VANGUARD Software Advisory Notice Release 6.1.P08A

This notice contains information on software improvements and changes made by the Vanguard Applications Ware Release 6.1.R000 patch 6.1.P08A which is based on 6.1.R000 and includes patch 6.1.T03A. The platforms affected are the Vanguard 6435 and 6455. This notice supplements the *Vanguard Applications Ware Release 6.1.R000 Software Release Notice* (Part Number T0001-42).

Figure 1. Revision Number Label

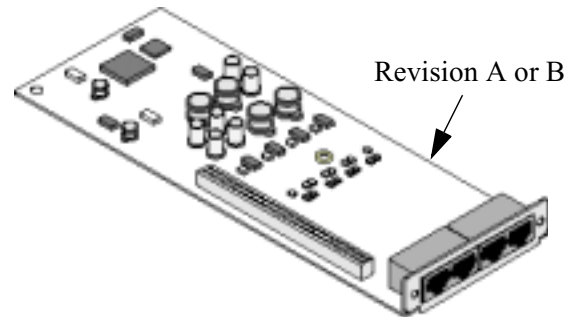
A manufacturing change in the SLIC chip design required the Quad FXS card to be revised from A to revision B. If you have a revision B Quad FXS card a 6.1 software patch is required (6.1.T03A). The Quad FXS revision B cards are not being recognized by software older than 6.1.T03A.

The arrow in Figure 1 shows the location of the revision label, located on the back right side of the Quad FXS card.

| <i>Quad FXS Card</i> | <i>Software Version</i> |
|----------------------------|-------------------------|
| Quad FXS Card - Revision B | 6.1.T03A and higher |
